Planning Commission Agenda Item

SUBJECT: SPR-07-2024 ASCEND AT TULE SPRINGS PARCEL 1.21 (Public Hearing). Applicant: D.R. Horton. Request: A Site Plan Review in an R-3 PCD (High Density Residential Planned Community District) to allow a 350-Unit, Multi-Family Development. Location: North of Clark County 215 and Approximately 1,200 Feet East of Revere Street. (APN 124-15-315-002). Ward 4. (For Possible Action)

RECOMMENDATION: APPROVE WITH CONDITIONS

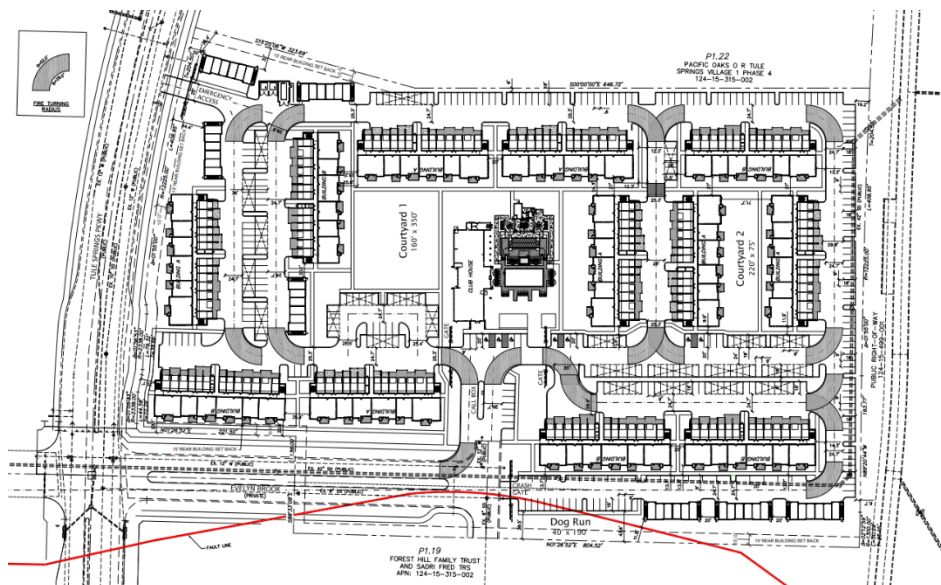
The proposed site plan has one access point for the development from Evelyn Brook Street and two (2) emergency access points from Evelyn Brook Street and Tule Springs Parkway. The subdivision is proposed to be gated with internal drives that are a minimum of 24' in width as required by the fire code.

The applicant has submitted a wall exhibit with the site plan. The applicant

is proposing a community theme wall along Tule Springs Parkway, a view fence along Evelyn Brook Street and precision block wall around the remainder of the site. However, the community theme wall, adhering to the Villages at Tule Springs Development Agreement, is required along both Tule Springs Parkway and CC-215. Additionally, the wall exhibit identifies two different view fences. Village 1 has two approved view fence designs, this development is required to use one of the previously approved designs. These are relatively minor changes and will be addressed during the building permit process.

The applicant is providing 733 parking spaces, where 716 are required, consisting of forty-two (42) carriage garage parking spaces, six (6) carriage tandem parking spaces, 373 garage parking spaces, 156 tandem parking spaces, and 156 surface parking spaces. The applicant intends to use tandem parking for a number of the units, this is permitted per DA-02-2024. The tandem spaces are in conjunction with a number of the garages, offering the tandem space in front of the garage. However, the site plan does not seem to provide enough depth for two spaces. The applicant must prove adequate depth is provided with the civil improvement plans. Bicycle parking is not being shown for the development. Multi-family developments require bicycle parking to be provided at 0.05 spaces per bedroom. The applicant is proposing to have 555 bedrooms which will require 28 bicycle spaces to be provided. The bicycle parking is a minor issue and can be addressed during the building permit process.

1. Unless expressly authorized through a variance, waiver or another approved method, this development shall comply with all applicable codes and ordinances.
2. All required tandem parking spaces shall not encroach into the required drive aisle or fire lane.
3. Bicycle parking shall be provided per the development standards. The applicant is currently proposing 555 bedrooms which requires 28 bicycle parking spaces. $(555 \times 0.05 = 27.75 \text{ spaces})$

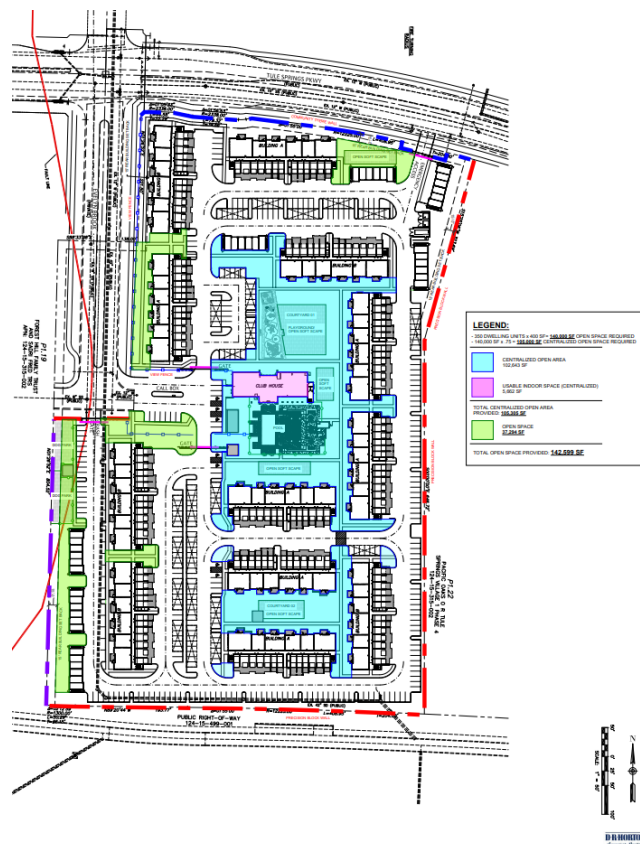
The open space requirements for multi-family developments require 400 square feet of open space for every multi-family dwelling unit. A minimum of 75% of the required common open space must be centralized for usable recreation space. Therefore, the proposed development requires 140,000 square feet of interior open space with 75% of that being usable for recreation. The applicant should provide a minimum of 105,000 square feet of amenities that can be utilized by the residents. Amenities such as pools, club houses, turf areas (natural or artificial), dog play area, tot lots, sports courts, picnic/bbq facilities, and defined walk/jog/run paths are all good examples of this. Areas that do not count towards this requirement are support/mechanical/maintenance buildings or areas, leasing/office space, rock or dirt landscape areas, walkways and general landscaping. Some of those

areas may be counted towards the overall open space, but not the 75% requirement for recreational open space. The applicant is proposing a total of 142,599 square feet of open space. Of that 102,643 square feet is centralized and 5,662 square feet of indoor recreation space within the clubhouse. The applicant has proposed the following open space amenities: pool; fitness center; clubhouse; playground with age appropriate equipment for two age groups (2-5 & 5-12 years of age); covered picnic facilities; courtyards; dog parks; and open softscapes. The specific details of the recreation amenities will reviewed during the building permitting with the city's parks planner.
